IREDELL COUNTY HEALTH DEPARTMENT

(SEPTIC TANK) IMPROVEMENTS PERMIT AND CERTIFICATE OF COMPLETION

OWNER OR CONTRACTOR Daniel J. Stageberg DATE April 11, 1990 PERMIT NO. 2L-A-21

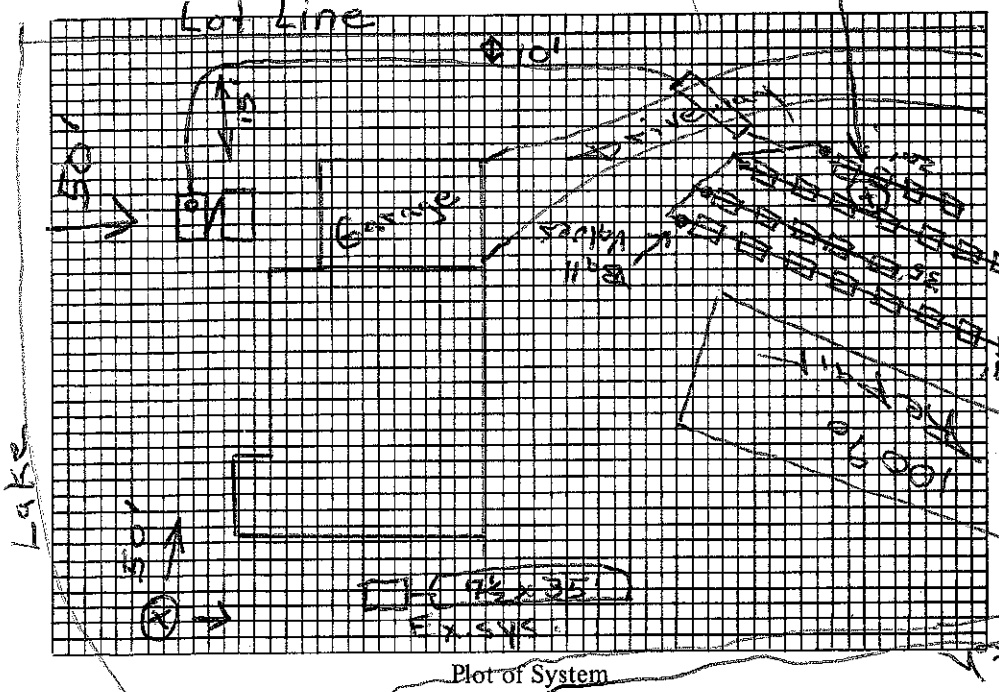
COMMENTS: (Supply Line) 2" 150' Schedule 40, (Laterals) 1¼" Sch. 40, 1 5/32" Hole per panel, Pump 23 gpm 27' TDH, * Existing Well Must Be Properly abandoned and verified by NRCD office

* Pipe underneath driveway must be sleeved in ductile iron

* Health Dept. will need to meet contractor on site before any alteration to drainfield area occurs.
